IN THE MATTER OF ADOPTING)
THE 2006 EDITION OF THE)
INTERNATIONAL RESIDENTIAL)
CODE)

RESOLUTION NO. R-10-0053

INTERNATIONAL RESIDENTIAL CODE

LINCOLN RESIDENTIAL BUILDING CODE

***FIGURE 404.1.1(5)**
10" PERMANENT POURED FOUNDATION
BASEMENT WALL SECTION(8' MAX HEIGHT)

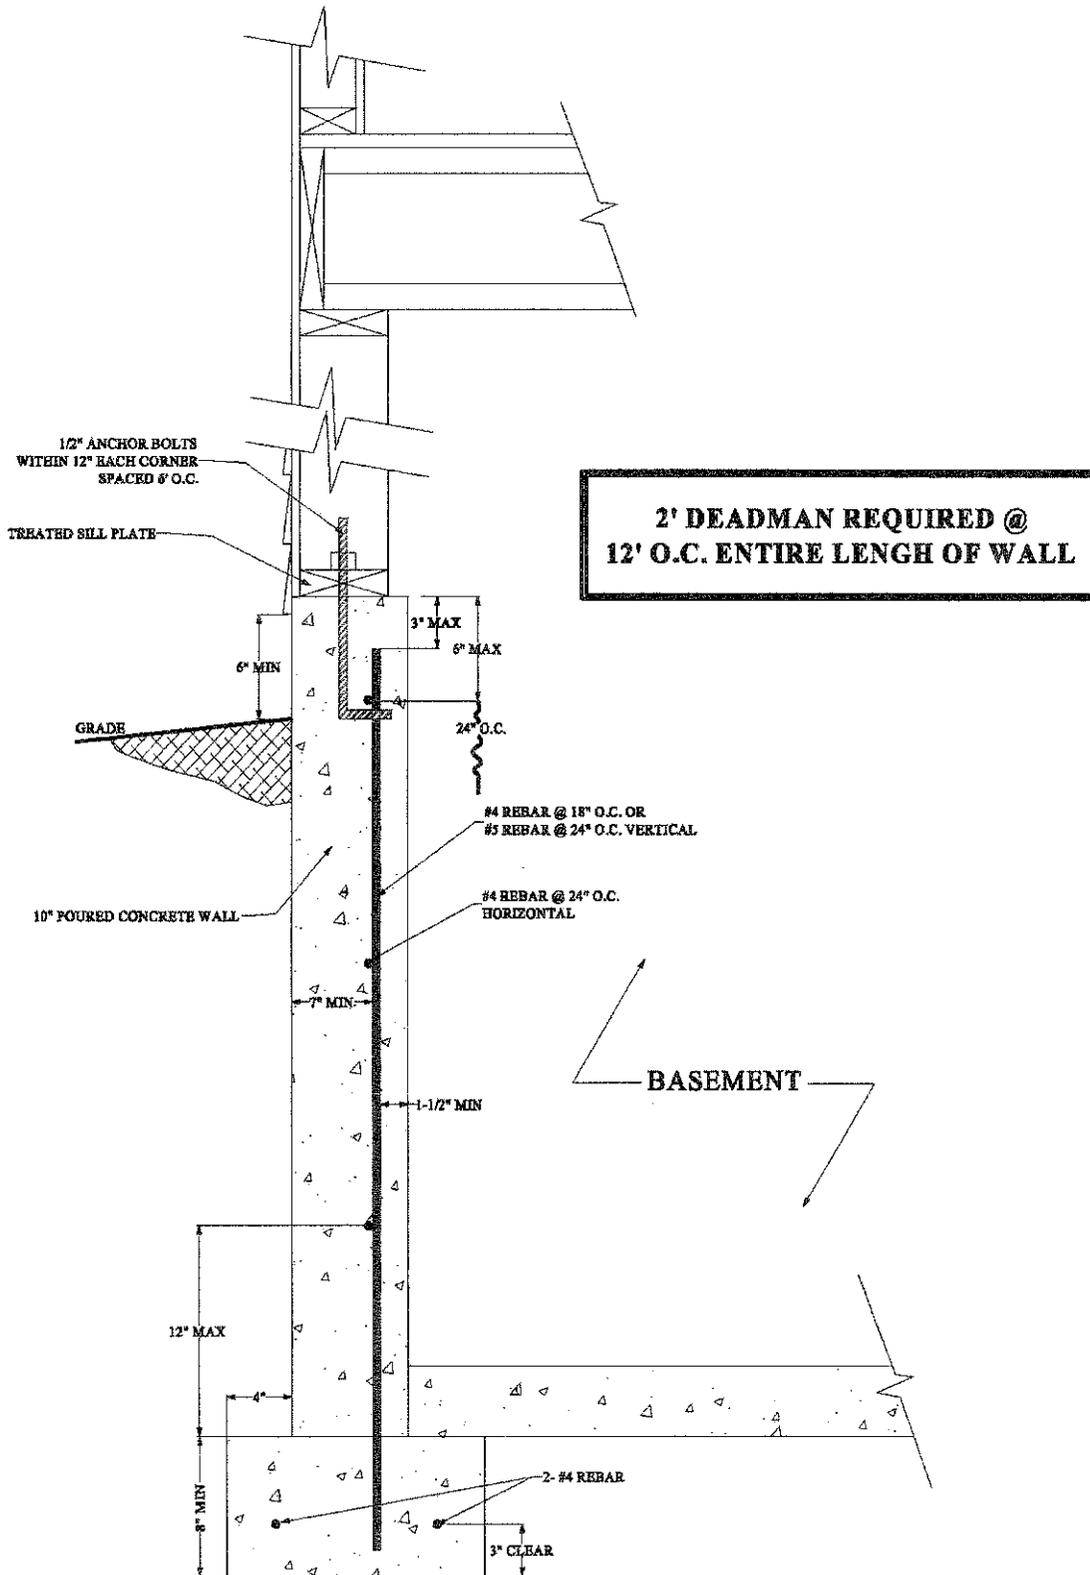
20.10.475 Table R404.1.1(5) Deleted; Figure R404.1.1(5) Added; Minimum Reinforcement; Residential Poured Walls.

Table R404.1.1(5) of the International Residential Code is hereby deleted and replaced with Figure R404.1.1(5) as shown on said figure at the end of this chapter. (Ord. 19033 §54; January 7, 2008).

***FIGURE R404.1.1(6)**
MIN. CONCRETE FOUNDATION
WALL CORNER DETAIL
(RESIDENTIAL POURED WALL)

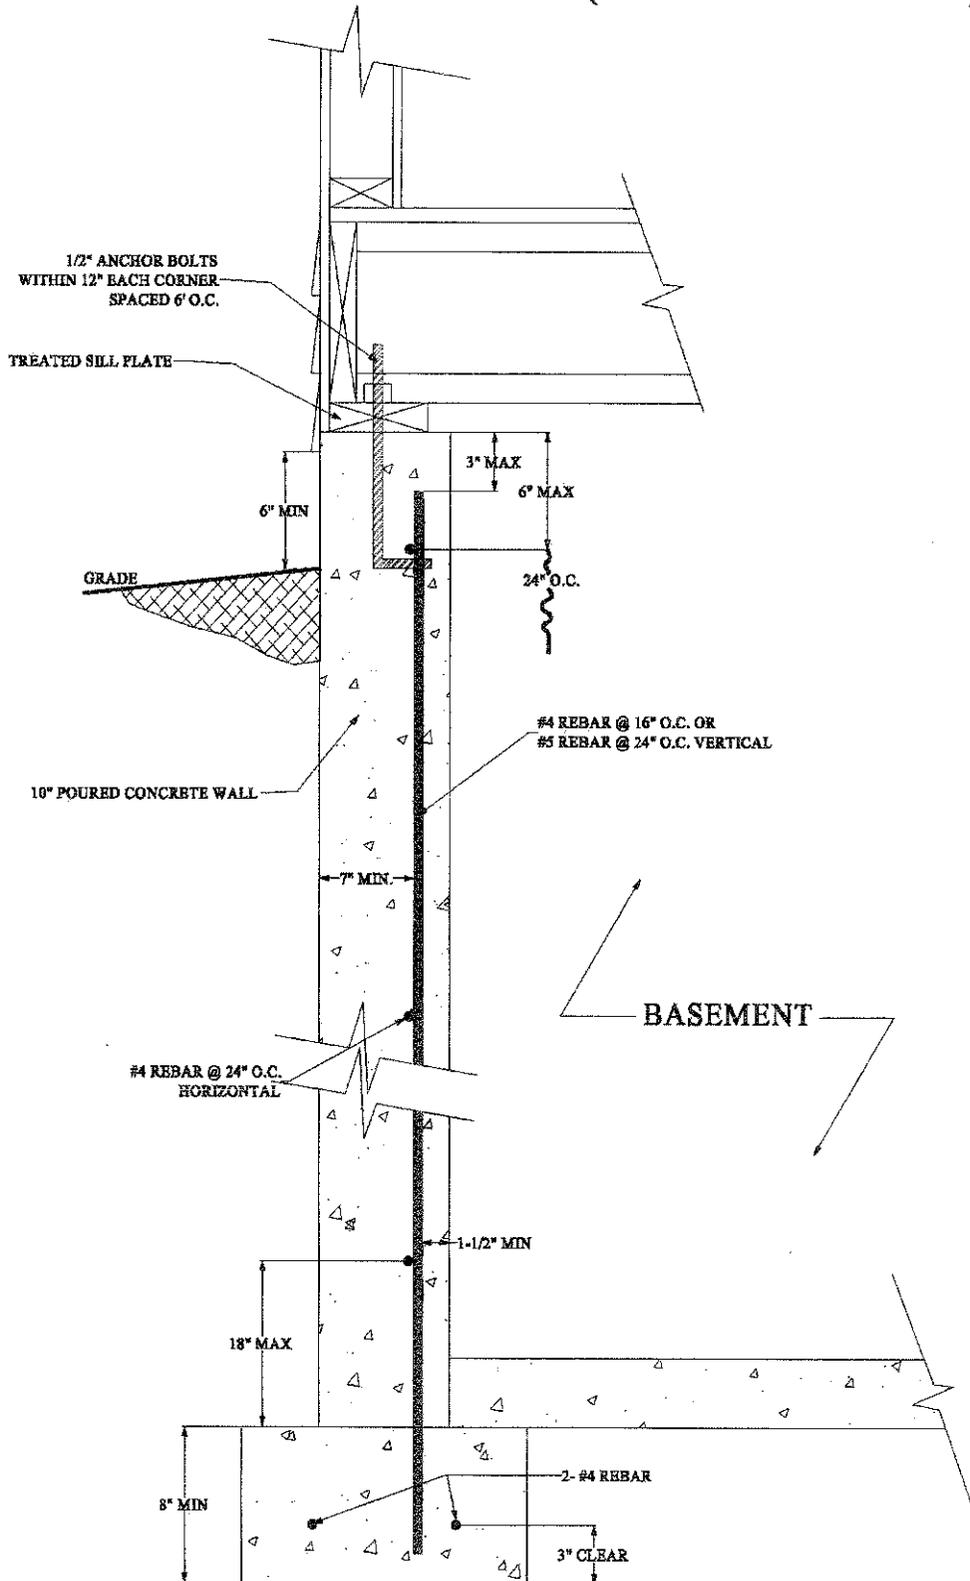
20.10.476 Figure R404.1.1(6) Added; Minimum Concrete Foundation Wall Corner Detail; Residential Poured Wall.

Figure R404.1.1(6) is added to the International Residential Code as shown on said figure at the end of this chapter. (Ord. 19033 §55; January 7, 2008).

***FIGURE 404.1.1(7)**
PERMANENT MASONRY FOUNDATION
BASEMENT WALL SECTION

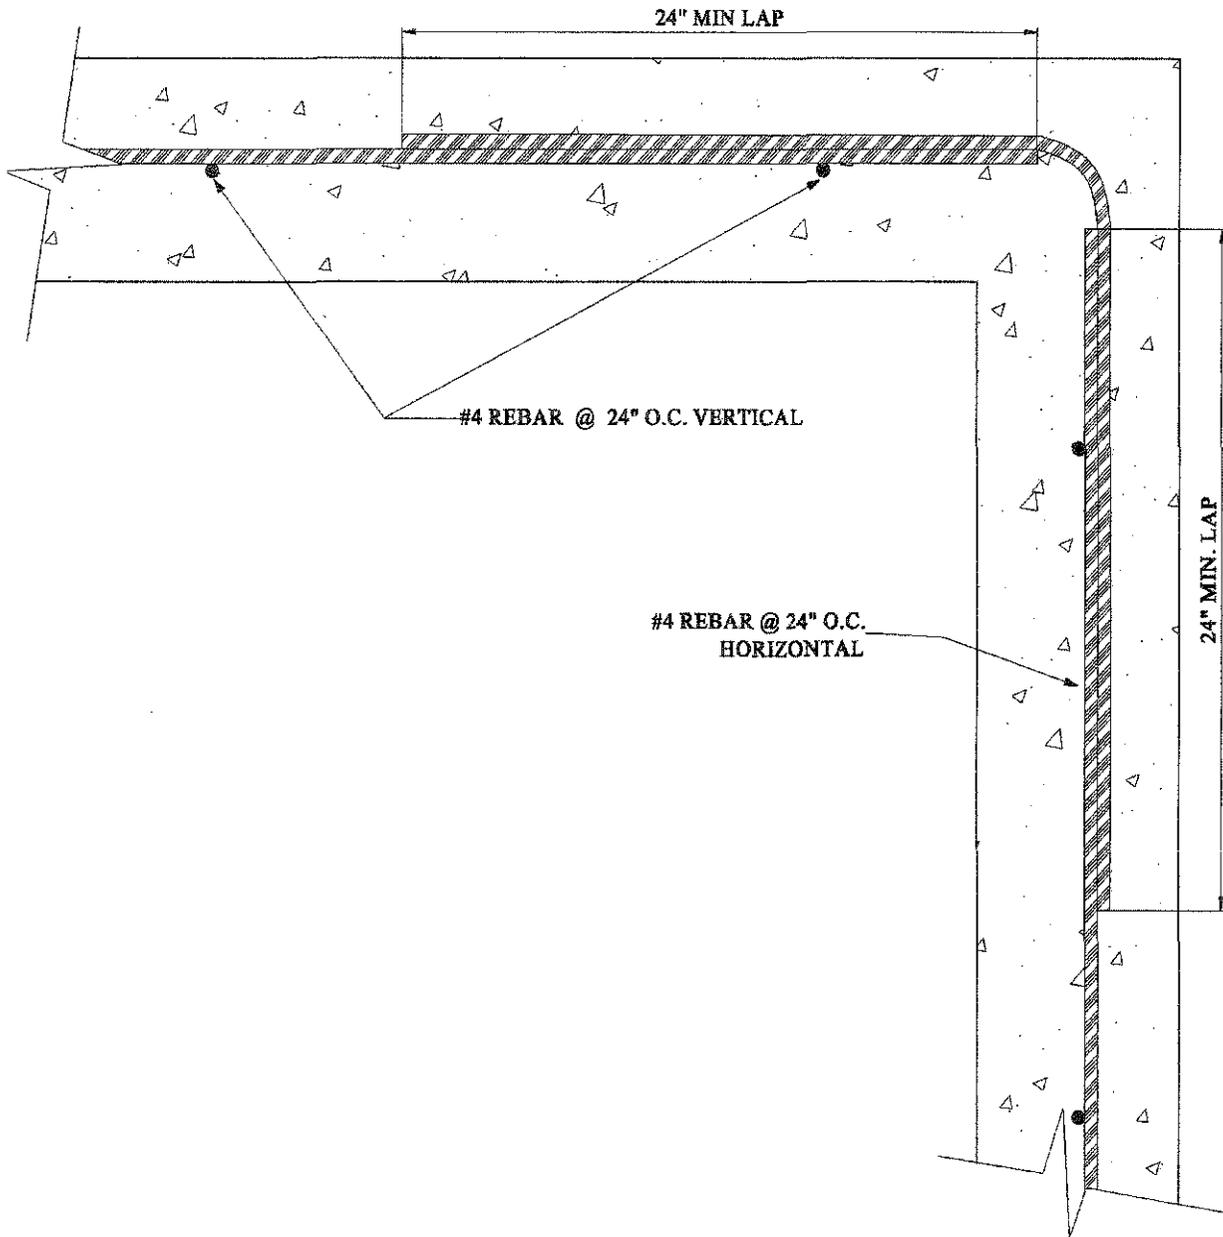
20.10.477 Figure R404.1.1(7) Added; Permanent Masonry Foundation Basement Wall Section.

Figure R404.1.1(7) is added to the International Residential Code as shown on said figure at the end of this chapter. (Ord. 19033 §56; January 7, 2008).
